Stage 1 Road Safety Audit Report (Feasibility)

**Helmsley House, Bartons Road,
Havant**

**Proposed new residential care home
development.
(Internal access road)**

Report Title: Stage 1 (Feasibility) Road Safety Audit

13. Identified Road Safety Audit Matters location plan

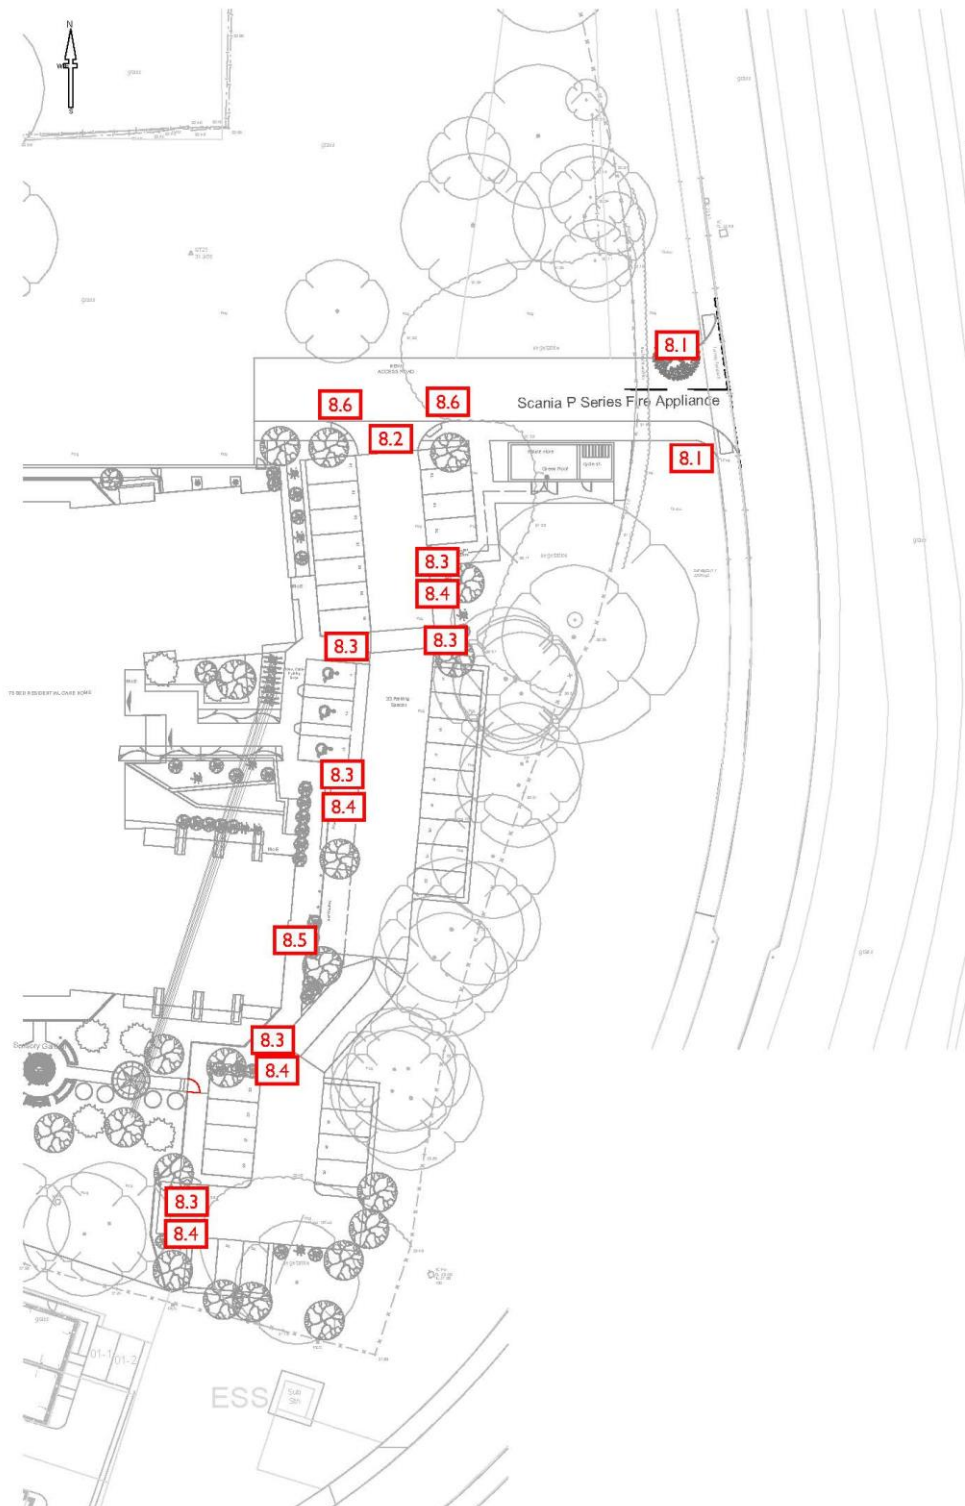
8.1 *Problem* (Item A1.5)	
Location:	Pedestrian crossing across junction with Normandy Way
Summary:	Vegetation located within pedestrian visibility splays obstructing visibility
 There currently is vegetation located along the western side of Normandy Way where the proposed access junction for the residential car development will be located. This vegetation will obstruct pedestrian visibility for pedestrians crossing the access road, reducing their visibility of oncoming vehicles. Remove vegetation from within visibility splays.	
TYPE OF CONFLICT/COLLISION	
Risk of pedestrian injury due to obstructed visibility caused by vegetation.	
RECOMMENDATION	
Remove vegetation from within required visibility splays.

8.2 *Problem* (Item A3.2)	
Location:	Internal junction
Summary:	Visibility splays not detailed
There is an internal junction detailed with no visibility splays shown. Collisions may occur if insufficient visibility is available to oncoming traffic. Ensure suitable visibility splays are detailed.	
TYPE OF CONFLICT/COLLISION	
Risk of collision due to restricted visibility,	
RECOMMENDATION	
Ensure suitable visibility splays are detailed.

8.3 *Problem* (Item A4.2)	
Location:	All internal pedestrian crossing points
Summary:	Visibility splays not detailed or incorrectly detailed
There are a number of pedestrian crossing points detailed on the drawing. All bar one do not have visibility splays detailed. The one crossing that does have visibility splays detailed are shown incorrectly. Pedestrians may be struck by vehicles if there is insufficient visibility at the crossing points to oncoming vehicles. Ensure suitable / correct visibility splays are detailed.	
TYPE OF CONFLICT/COLLISION	
Pedestrians may be struck by vehicles if there is insufficient visibility at the crossing points to oncoming vehicles.	
RECOMMENDATION	
Ensure suitable / correct visibility splays are detailed.

8.4 *Problem* (Item A4.6)	
Location:	Various pedestrian entry points to car park
Summary:	Pedestrians not warned they are entering a shared space
There are dropped kerb entry points to the car park detailed on the drawings. The key on the drawing states 'drop kerb with tactile paving' for the symbols used at these entry points. There are no opposing landing areas at these dropped kerbs, only a shared car park area. Corduroy paving has not been detailed to warn visually impaired pedestrians that they are entering a shared space environment. Visually impaired pedestrians may not take extra care and walk into the path of vehicles. Provide corduroy warning paving at all pedestrian entry points to the car park.	
TYPE OF CONFLICT/COLLISION	
Visually impaired pedestrians may not take extra care and walk into the path of vehicles.	
RECOMMENDATION	
Detail corduroy warning paving instead of tactile paving at all pedestrian entry points to the car park.

8.5 *Problem* (Item A4.6)	
Location:	Steps in footway
Summary:	Trip / fall hazard
There is a set of steps detailed in the footway adjacent to the delivery bay. No handrail warning corduroy paving or street lighting has been detailed at these steps. Visually impaired pedestrians may not be aware of the steps and may trip up or fall down them. Mobility impaired pedestrians may have difficulty climbing the stairs without a handrail and may fall. Provide handrails, warning corduroy paving, and lighting at these steps.	
TYPE OF CONFLICT/COLLISION	
Risk of pedestrian trip or fall from a lack of warning or aid.	
RECOMMENDATION	
Provide handrails, warning corduroy paving, and lighting at these steps.

8.6 *Problem* (Item A4.6)	
Location:	Pedestrian crossing point across internal junction
Summary:	Tactile paving detailed guiding pedestrian incorrectly
There is a pedestrian crossing point shown across the internal junction. The alignment of the tactile paving detailed on the drawing would incorrectly guide pedestrians into the New Access Road and not across side road. Visually impaired pedestrians that rely on this type of paving may be guided into oncoming traffic or have difficulty negotiating over full-height kerbs at the northern verge. Align the tactile paving across the crossing point correctly.	
TYPE OF CONFLICT/COLLISION	
Risk of pedestrian injury from collision of negotiating full-height kerbing.	
RECOMMENDATION	
Align the tactile paving across the crossing point correctly.

8.1	Vegetation located within pedestrian visibility splays obstructing visibility	Vegetation will be cleared prior to commencing works so not an issue

8.2	No junction visibility splay detailed at internal junction	Visibility splay shown	
8.3	No or incorrect pedestrian visibility splays detailed at internal pedestrian crossing points	Pedestrian visibility splays added and amended

8.4	Incorrect paving type detailed at entry to shared space / car park	Paving type and orientation amended	
8.5	No warning corduroy paving, hand rails, or lighting detailed at steps	Corduroy paving shown. Handrails will be provided and the steps will have sufficient lighting but to be covered as part of detailed design phase

8.6	Incorrectly aligned tactile paving	Noted and now corrected
